CITY OF NOVI CITY COUNCIL DECEMBER 16, 2024

SUBJECT: Initial review of eligibility of The Grove, to rezone property at the southeast corner of Twelve Mile Road and Meadowbrook Road to High-Density Multiple Family with a Planned Rezoning Overlay.

SUBMITTING DEPARTMENT: Community Development – Planning Division

THE VILLAGES Existing Vegetation. No Excavation within Woodland Limits

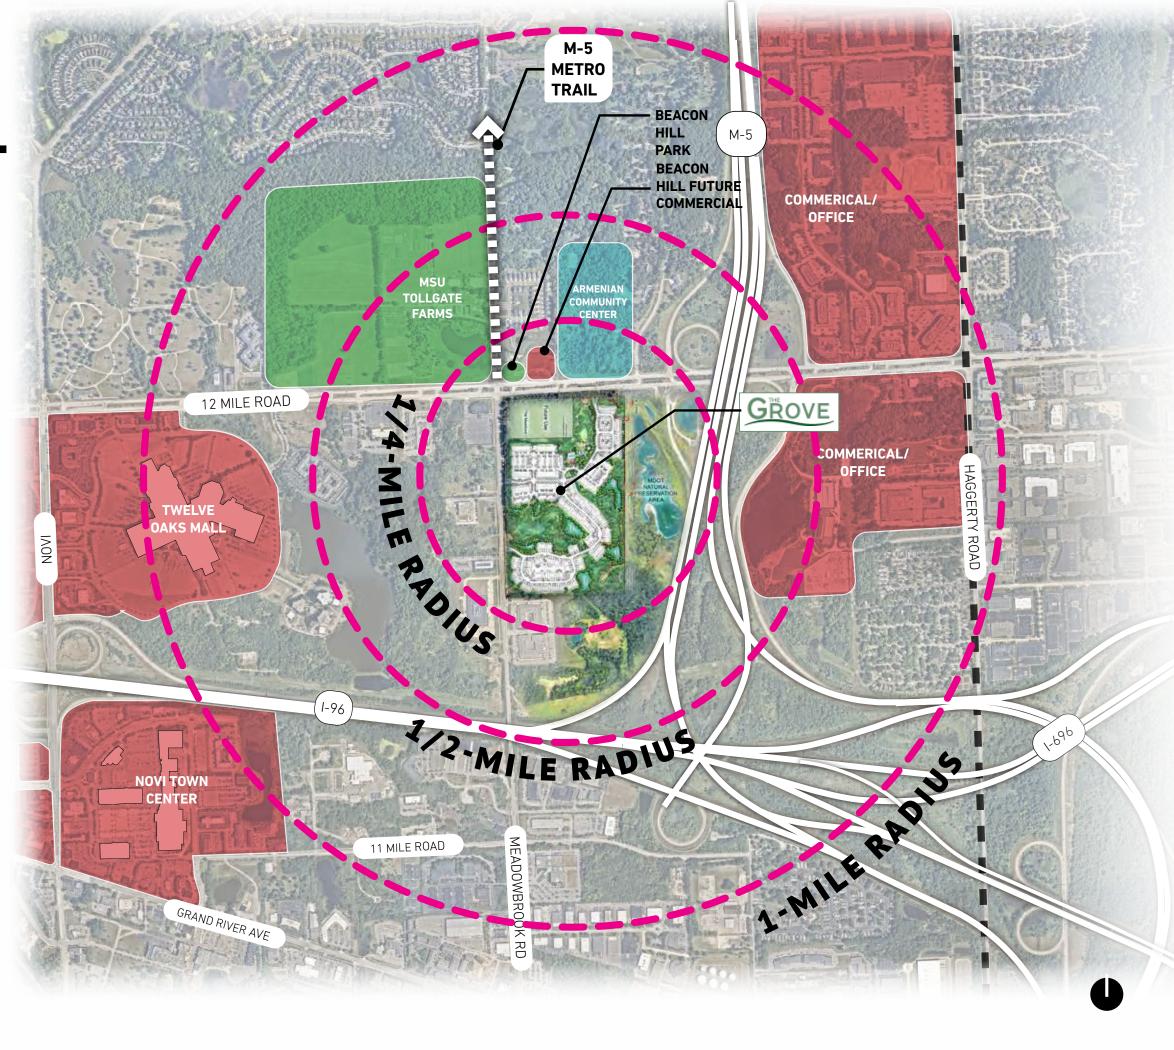
As described in the Wetland Review, each of the delineated wetlands on the site meet the criteria of providing wildlife habitat as well as flood and storm control. Wetland review notes that the proposed development appears to result in a total permanent wetland impact area of 1.71 acres out of the total 9.64 acres present on site (about 18% impact). Approximately 1.4 acres of on-site mitigation area is noted on the plan, which is not likely to meet the full requirement for mitigation. The City has determined that all wetlands on the site are regulated, and therefore the wetland impacts, and mitigation calculation requirements should be updated accordingly on future submittals. For woodlands, the plan appears to remove about 75% of the regulated trees on the woodland survey.
